Ref. 2021/0500/P

Delegated Report Members Briefing		Analysis sheet		Expiry Date:	25/04/2021
				Consultation Expiry Date:	24/04/2021
Officer			Application Number		
John Sheehy			2021/0500/P		
Application Address			Drawing Numbers		
49 Leverton Street London NW5 2PE			See decision		
PO 3/4	Area Team Signature	C&UD	Authorised Officer Signature		
Proposal					
Enlargement of ground floor rear addition with new openings to internal courtyard, installation of a sliding timber garage door to Railey Mews in place of garage door and two rooflights to main roof.					
Recommendation:		Grant conditional permission			
Application Type:		Full planning permission

Proposal: Enlargement of ground floor rear addition with new openings to internal courtyard, installation of a sliding timber garage door to Railey Mews in place of garage door and two rooflights to main roof.

2. View from Railey Mews

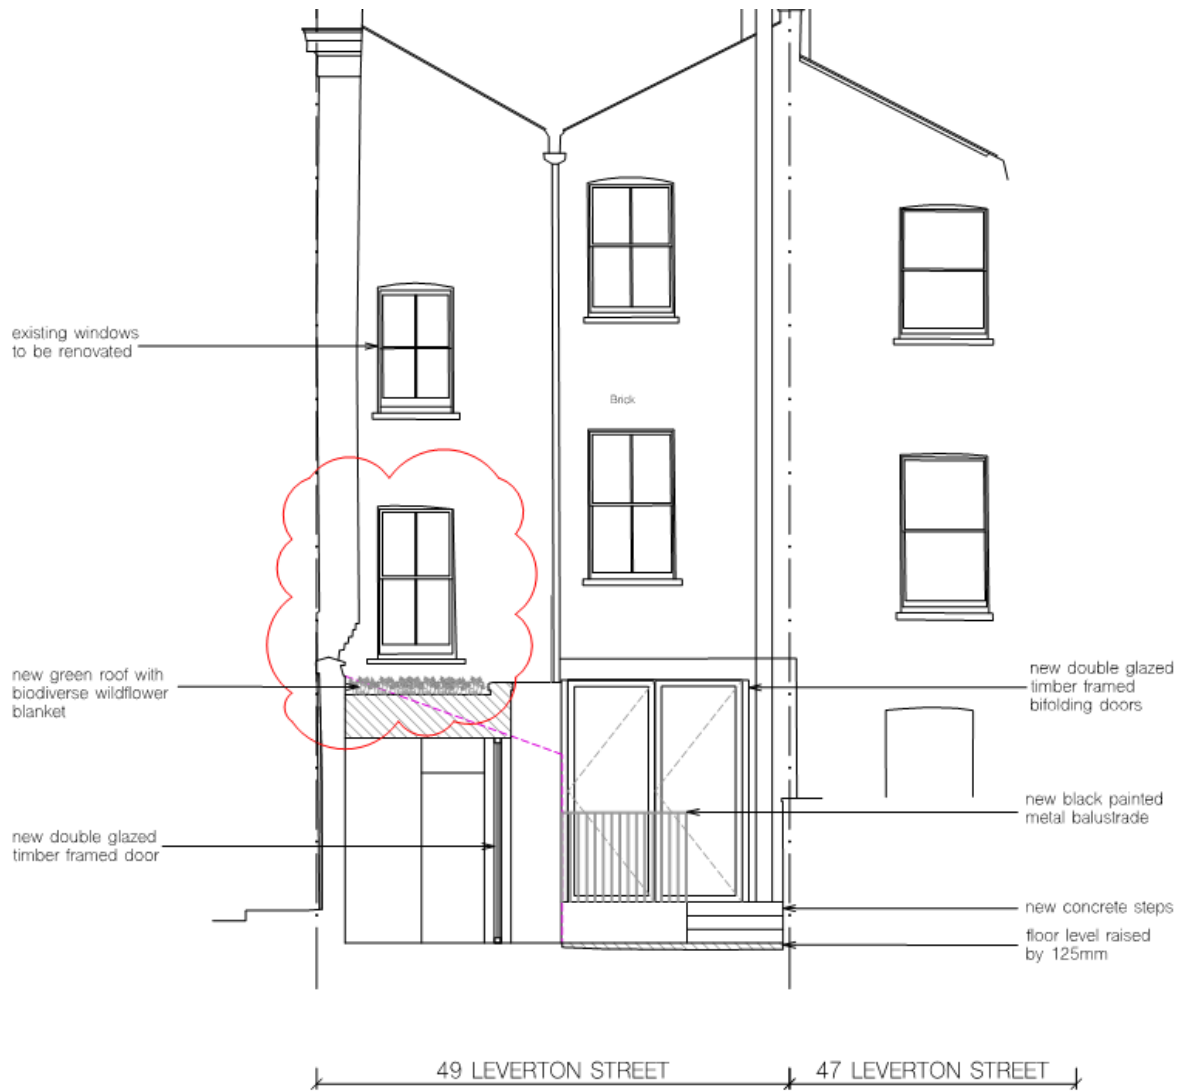
1. Noise and loss of privacy from the new use will impact the amenity of the immediate dwellings and residents use of the mews.

The proposed terrace abuts a narrow section of mews, the parapet is 2.8 meters from the pavement creating an objectionable overlooking impact to residents use of the street. 49 Leverton street entrance of Railey mews is the primary ingress and egress for residents to the local shop, Pineapple pub and public transport.

2. The visual impact will change the character of the mews.

Sliding Garage doors:

In the open position the proposed garage door creates the impression of a double width garage altering the symmetry and character of the mews. It is assumed by the door design and second door and planter behind - the intention is for the sliding garage door to remain open for extended periods of time.

Officers response: for assessment of sliding door please see paragraph 3.6-3.8 in Design/ Conservation section below

3.6 On the elevation onto Railey Mews a sliding door would replace the garage door. A stretch of wall 2.35m in length would be rebuilt and recessed to a depth of 0.15m to allow the door to slide along a rail at the top.

3.7 The proposal door would be the same size as the existing garage door and would be made of vertically slatted timber, like the existing, with a metal frame - the existing has metal hinges on the front in the style of a barn door.

3.8 The proposed sliding door is acceptable for the following reasons:

- The L-shaped extension dates from the 1960s. The garage door is not an original feature nor is the rendered wall;
- The proposed sliding door is of utilitarian design and would not introduce a decorative element into the mews. Traditional mews lanes such as Rainey Mews were places where, in the past small businesses were based. The mews properties had large openings at ground floor to enable the delivery of materials. Their working character is still visible in some buildings along the mews. The sense of the mews having been a working environment in the past would be retained by the sliding door;

- The sliding door is unlikely to be retained in an open position at all times because the room it serves, a living room, would also benefit from large windows onto the courtyard. However, even if it was retained in an open position the sliding design would be legible so would not undermine the utilitarian character of the mews;

- The existing garage door opens outwards and obstructs the footway and part of the roadway when open. The sliding design would remove this hazard.
